#### **ALPINE CITY PLANNING COMMISSION MEETING**

**SUBJECT:** Extension of Non-Conforming Building – 1031 E. 300 N.

#### ALPINE PLANNING COMMISSION AGENDA

SHEET NUMBER:
A-2.0
07/07/2020

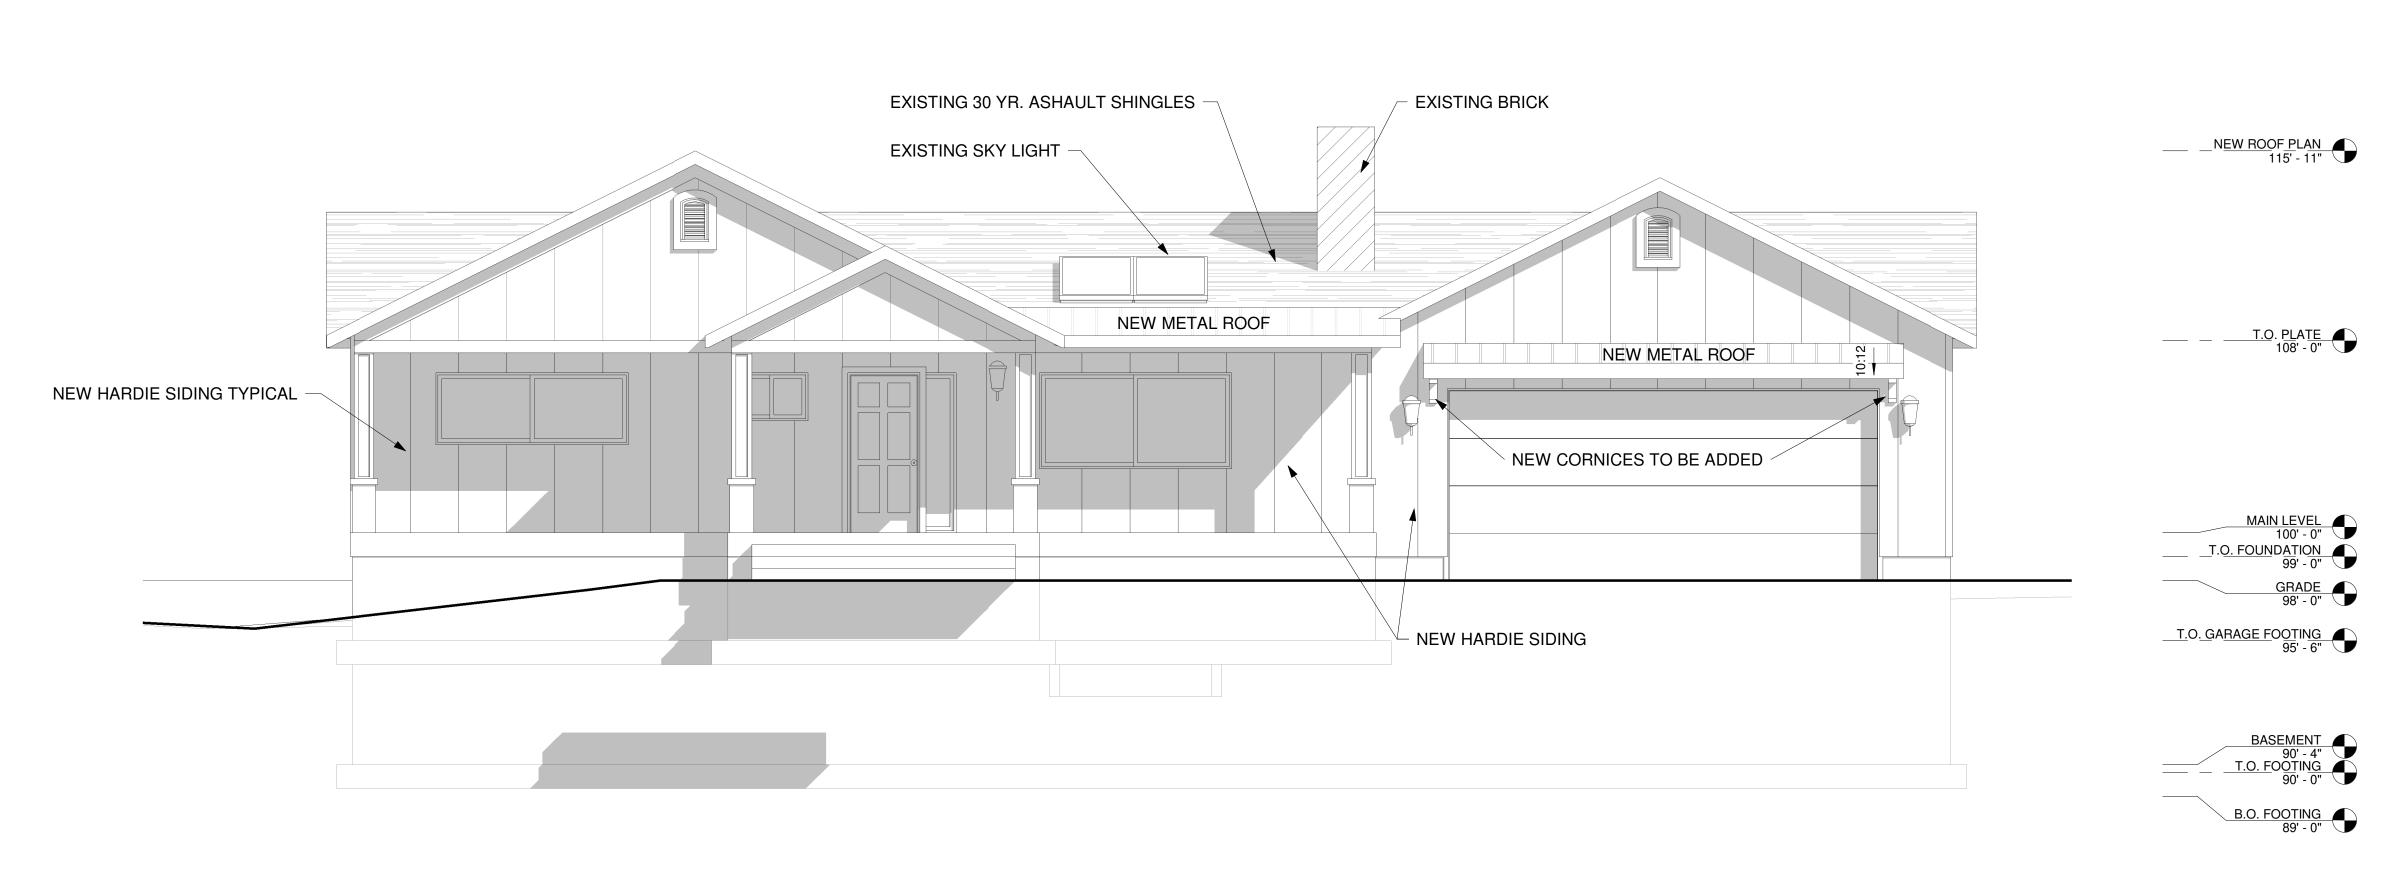
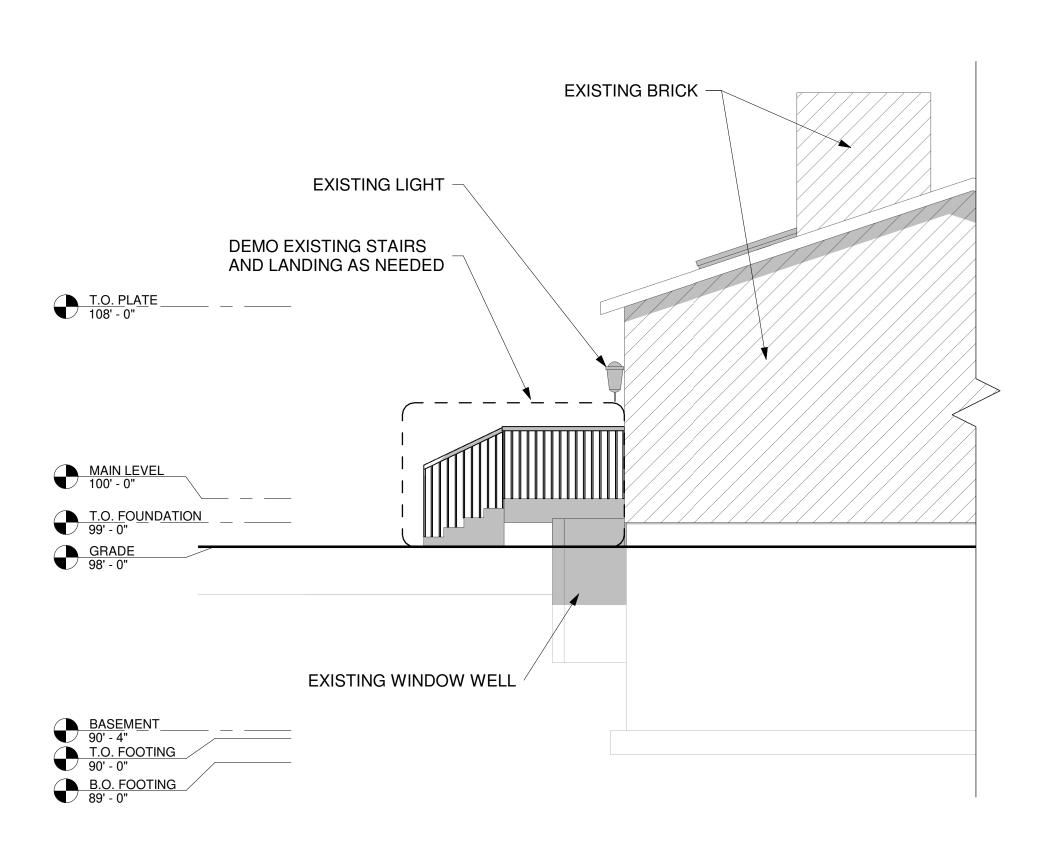
The Carson home is an existing non-conforming building which does not meet setback requirements of the CR-40,000 zone. Minimum side setback for the zone is 12 feet, and the home has a setback of 10 feet 4 inches. Plans show the proposed porch within the 12-foot side setback.

According to 3.22.070.1 of the Alpine City Development Code an addition or extension of a non-conforming building must "...conform with all existing setback and location requirements". The proposed addition appears to meet all other requirements outlined in code.

Staff recommends that the proposed extension be approved with the condition that the proposed porch can meet the current setbacks of the CR-40,000 zone.

Approve the proposed extension with the condition that it meet setback requirements of the zone.
